ONSITE SEWAGE DISPOSAL SYSTEM

PROPERTY ADDRESS: 11915 Simpson Road

11915 SW SIMPSON ROAD
CLARKSVILLE, MD 21029
LOT 8, PLAT 14485, MAP 41
GRID 7, 1.00 ACRES, ACCT#05-434408
ONSITE SEWAGE DISPOSAL
SYSTEM DESIGN PLAN

From: Oswald Jr, Woodin
Sent: Wednesday, July 9, 2025 8:04 AM
To: Jim Witmer
Subject: OSDS Plan_11915 Simpson Road
Attachments: proposed trench layout_250709_075617.pdf

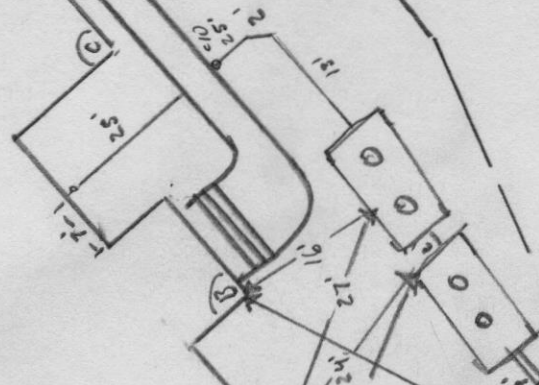
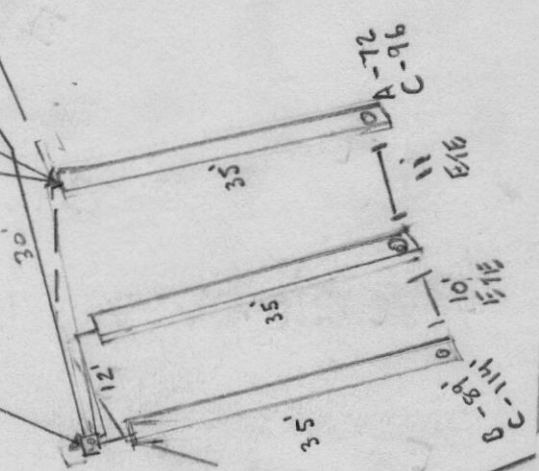
4/16/2026-Installer on site for FIO. All work still uncovered. no
 near foundation. SCHO 40 4" PVC used. Adequate fill to st. Both st
 & pt open & checked w/ 4' level, < 3' cover on both. 4' of sleeve
 coming out of pt protecting 2", rest of 2" connected to d-box. ac to Baffle (SP)

3/24/2026-Installer on site for pre-con. Fill on portion of SOA, installer
 dug down to original grade. Shot contour, moved trenches up & 6' closer together. Trenches
 36' long, on contour, 13' apart, & within SOA per plan. 12" offsets' staked per plan.
 well > 100' from SOA, on to start work. (SP)

4/2/26 Contractor completed upper trench and is currently digging middle trench. Upper trench has 8' bottom and 2.5' inlet. Stone
 is from Barrier - #2 double-sieved, and marginal with fines attached. Size of stone ok. D-box has been sent Contractor to set
 Septic tanks tomorrow. Told Contractor since if he can dig off tomorrow that Tank/pump tank cannot be covered. Contractor
 to backfill around tank to prevent tank from floating. (SP) PM inspection done. Contractor on site. Stone on.
 Middle trench finished, inlet @ 2.5'. onsite while lower trench installed, bottom @ 8' & inlet @ 2.5'.
 stone & fabric on. 90' turn down installed @ d-box. 30' of 280 PSI 2" FM installed. (SP)
 6/9/26 - pump & alarm ok. (SP)

**WALL CHECK FOR:
11915 SW SIMPSON ROAD**

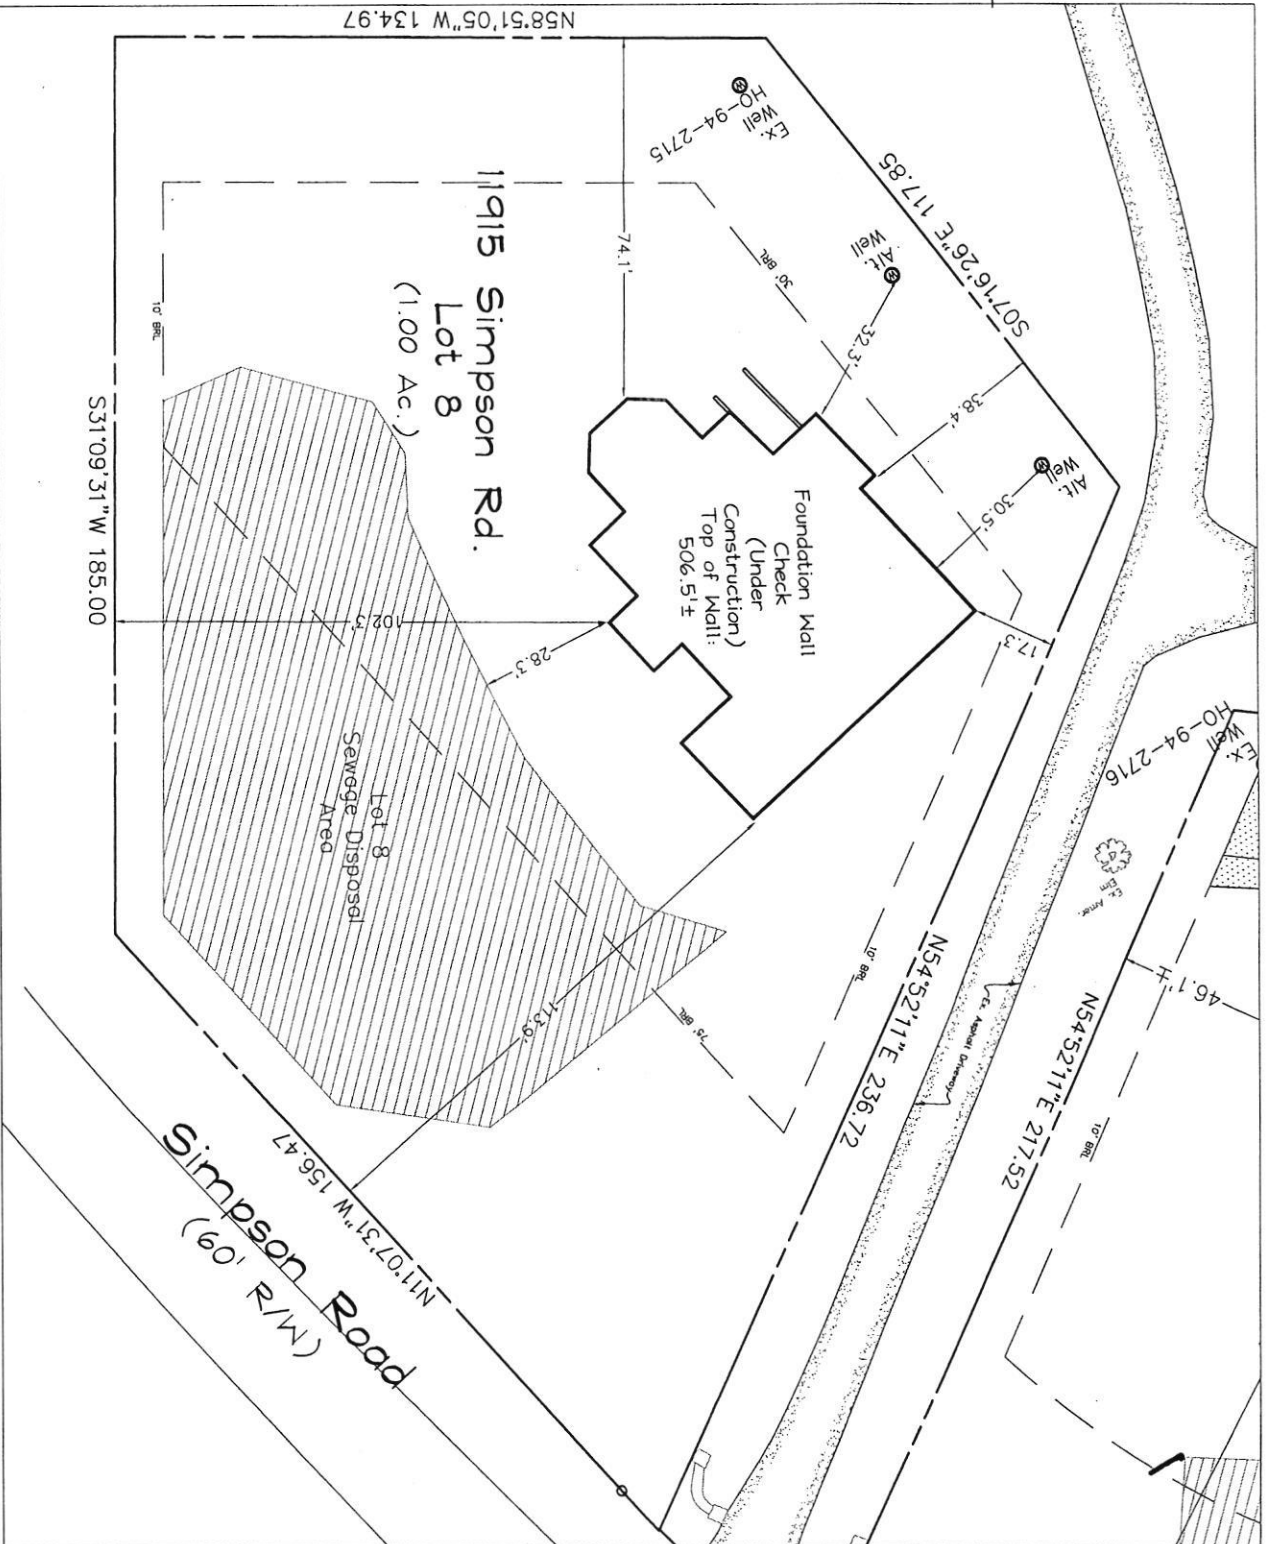
*Will check
OK 2/18/26
-H.O.*

ONSITE SEWAGE DISPOSAL DESIGN PLAN

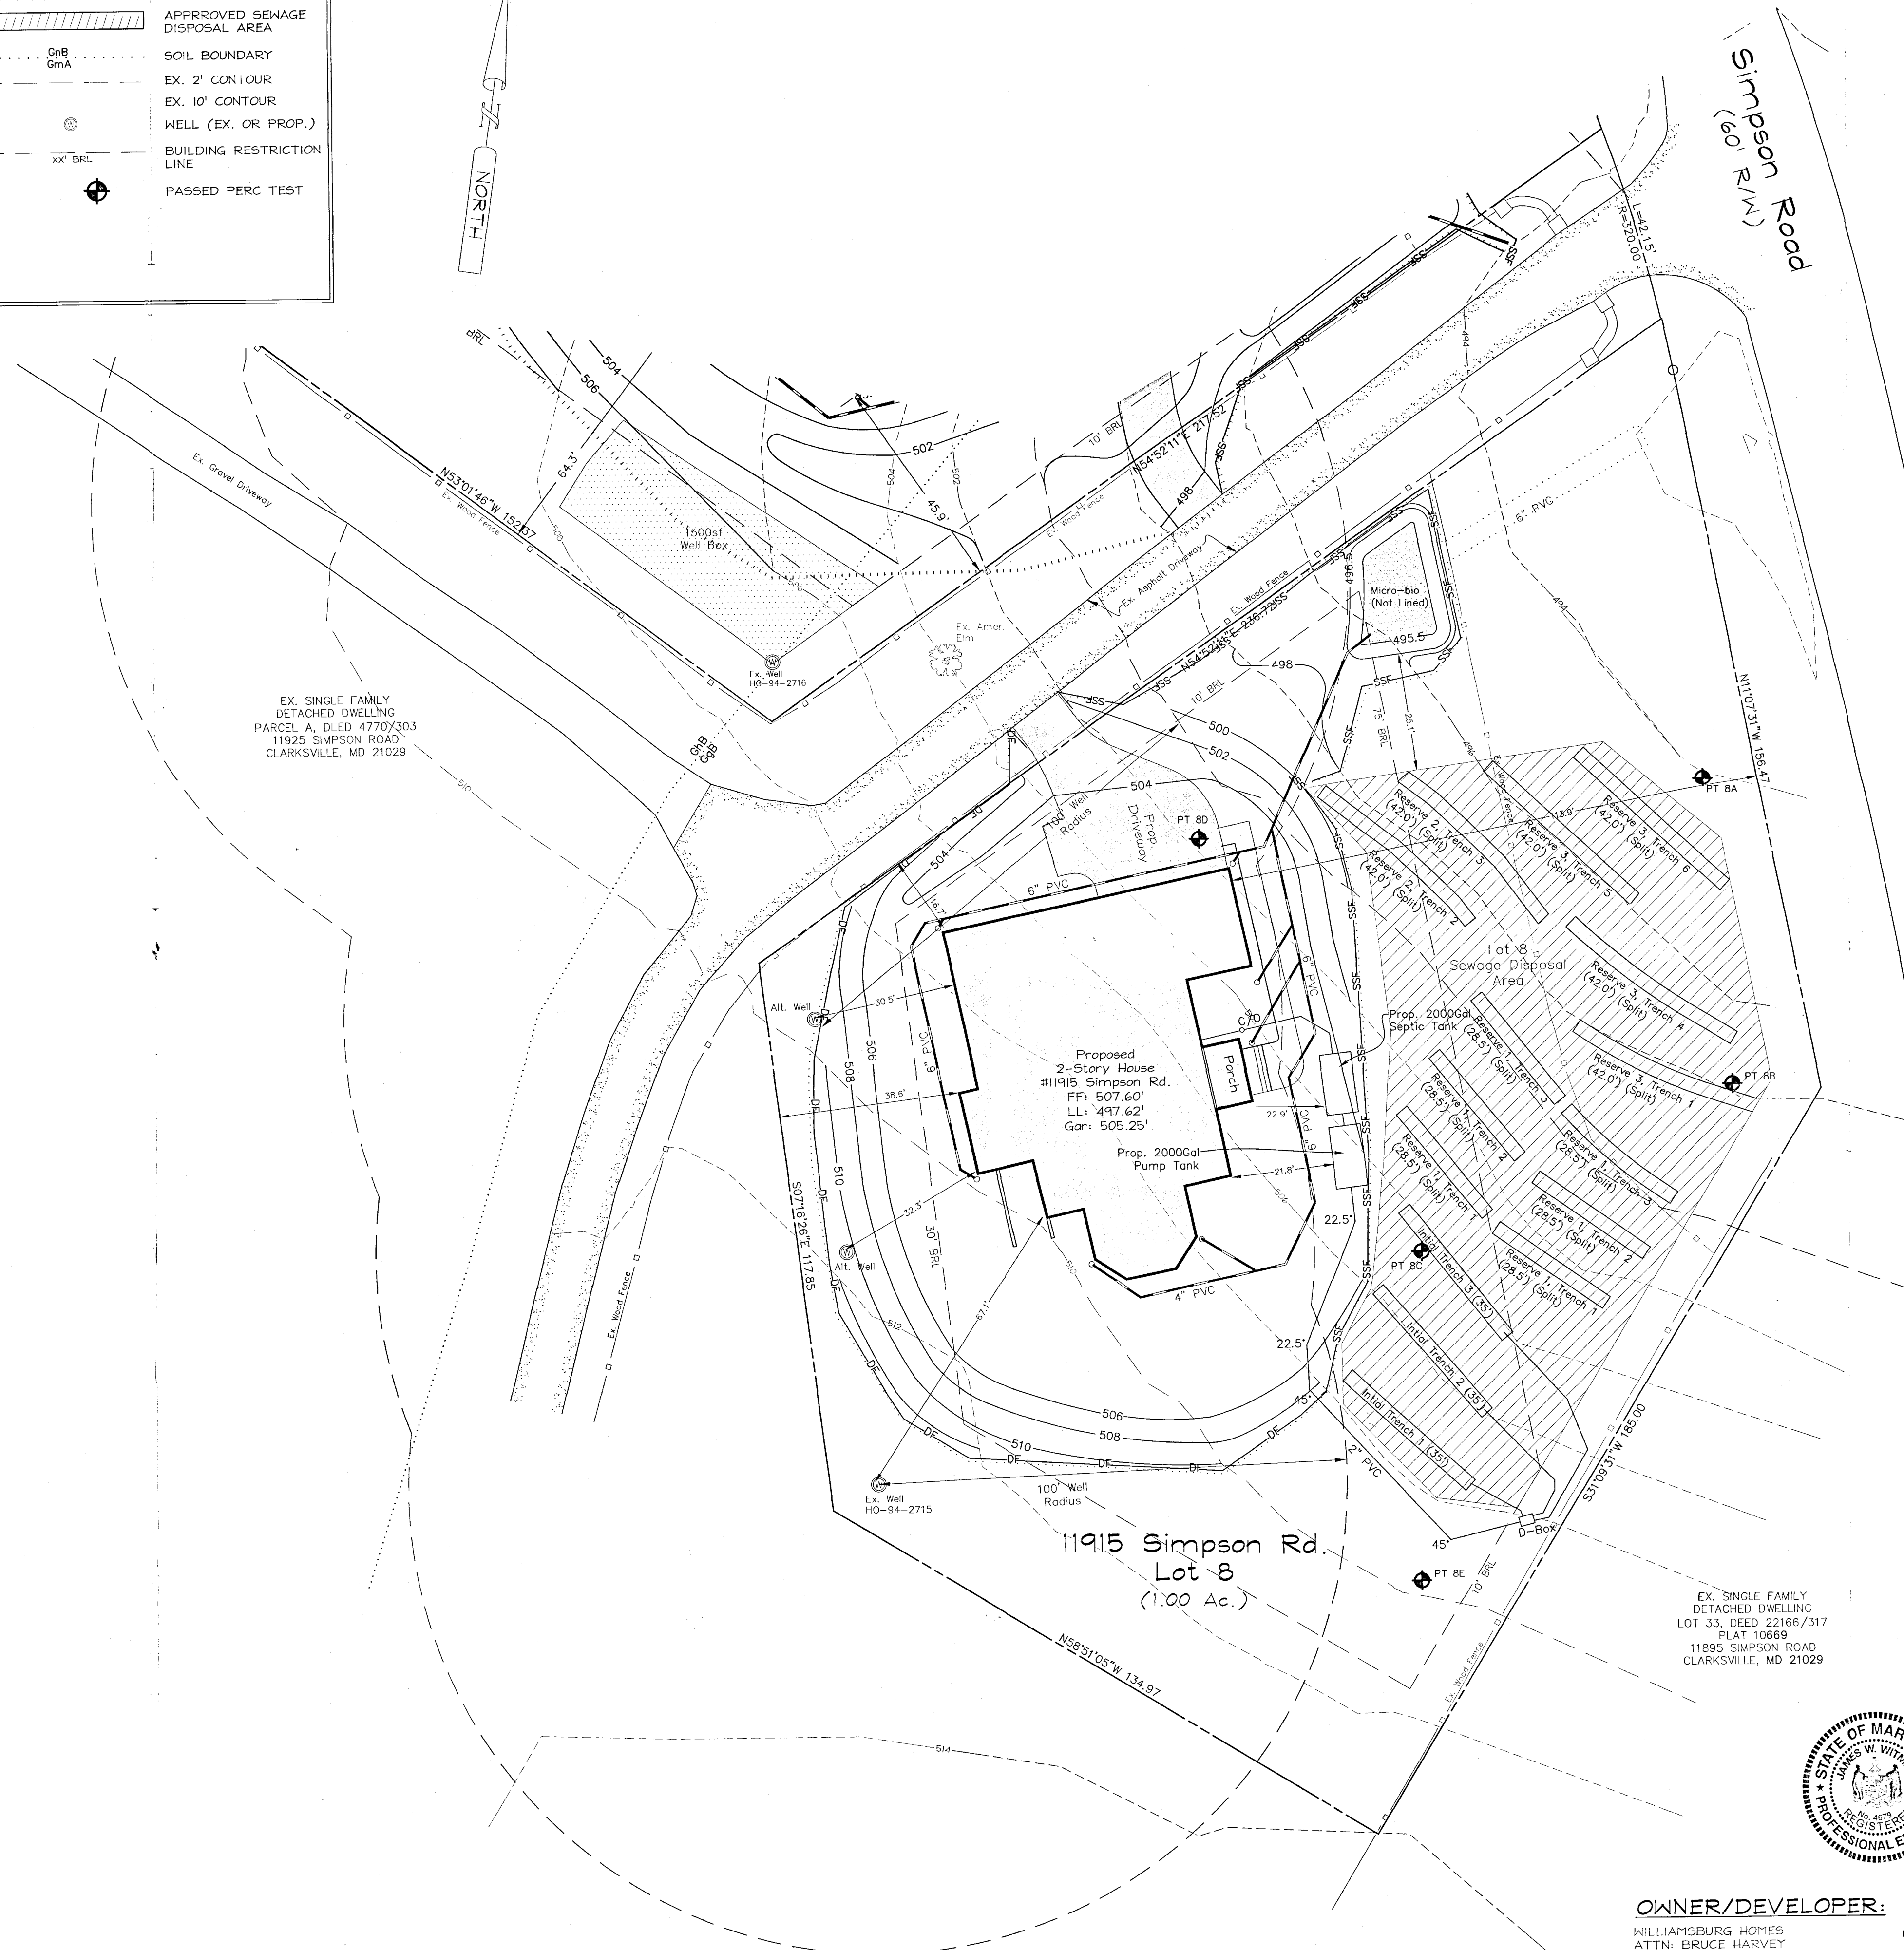
Good morning. Thanks for making the requested revisions to the plan, however the trenches need to be a little more on contour. I suggest sliding the initial system down a bit, and bringing the d-box over to the other side (see suggested layouts). You might be able to fit everything in once you have it to scale. For the 2nd replacement system, its okay if the last split trench isn't side by side. It's going to be close. Let me know what you think.
